**RE: SYDNEY METRO VICTORIA CROSS OVER STATION
DEVELOPMENT (SSD8874)**

Victoria Cross Over Station Development Response to Submissions Report

Figure 01: Concept Victoria Cross OSD

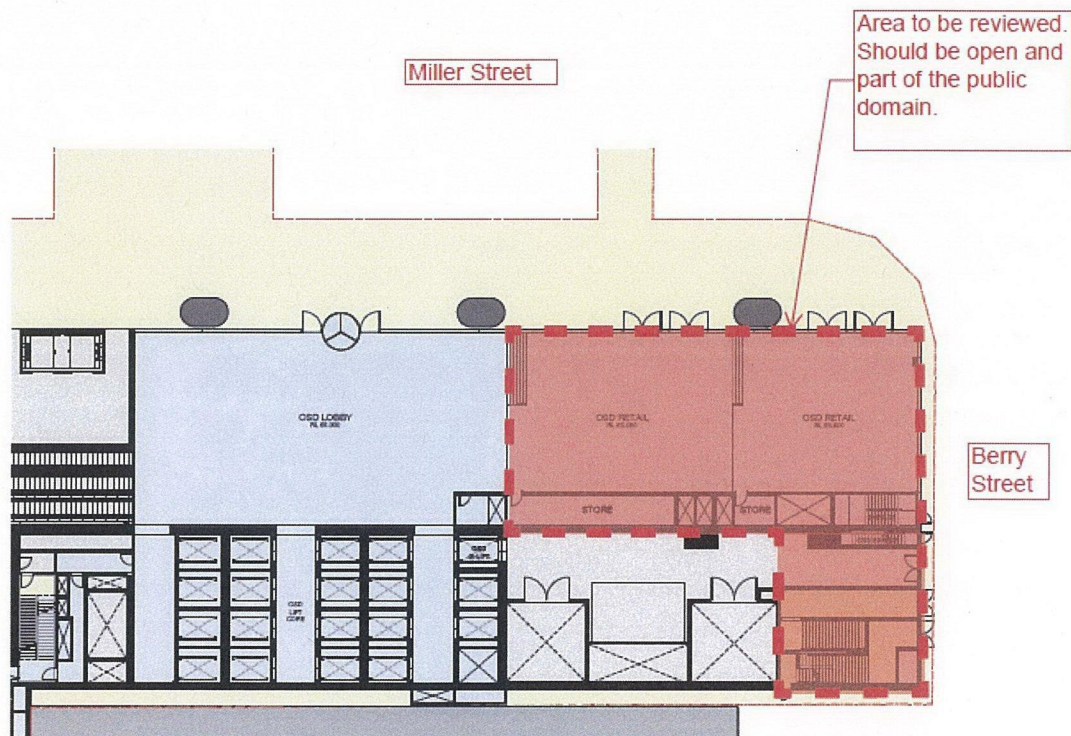
The concept stage of the Victoria Cross Station development indicated an open forecourt on the corner of Berry St and Miller St as shown in Figure 01 below. Subsequent design drawings show this important space as 'glassed-in' and no longer publicly accessible (Figure 02). Pedestrian modelling undertaken under the CBD Transport masterplan indicates a volume increase of 300% at this particular junction. The removal of this publicly accessible space will be detrimental to the public domain outcome and does not meet council strategic guidelines for the future amenity for North Sydney CBD.

Figure 02 highlights the areas of space that require review. There is scope for these spaces to be re-designed to meet the original design concept objectives. We request that this space be reviewed to meet future pedestrian growth figures as well as provide an outstanding urban design outcome for the most prominent sun-lit corner of the CBD.

Figure 5.3 — Indicative station design – public domain and open space

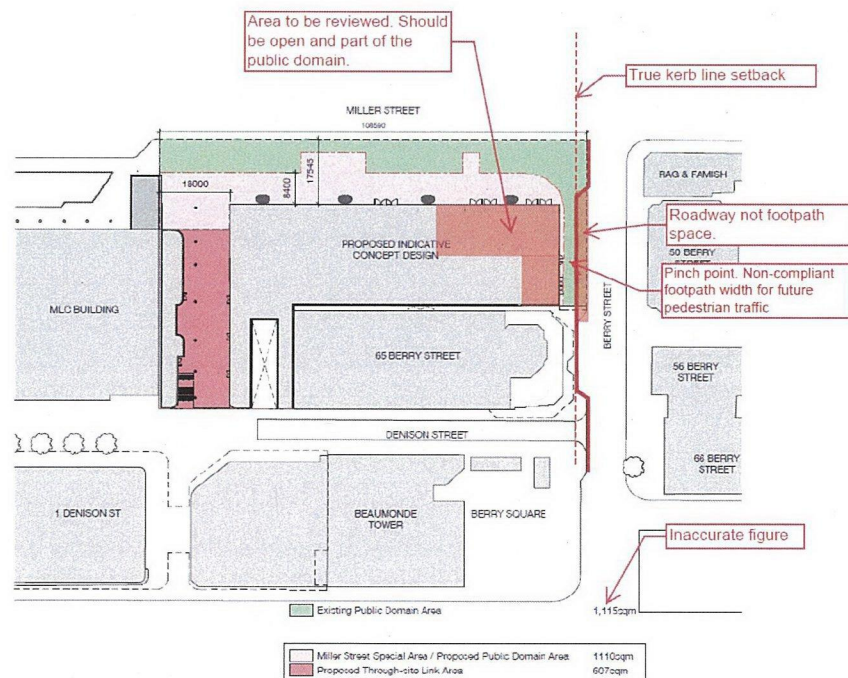
Figure 5.3 in the *Response to Submissions Report* is inaccurate and does not reflect the correct kerb to building setback. This base diagram has been used throughout the various Sydney Metro reports and continually misleads as to the true setback on Berry St. The parking bays do not end at 65 Berry St rather they extend to approximately 14m from edge of Miller St creating a reduced setback and reduced footpath width that will not be adequate for the expected numbers of pedestrians along this strip of Berry St post-Metro. This pinch-point along one of North Sydney's busiest streets is unacceptable. See diagram below for further clarification.
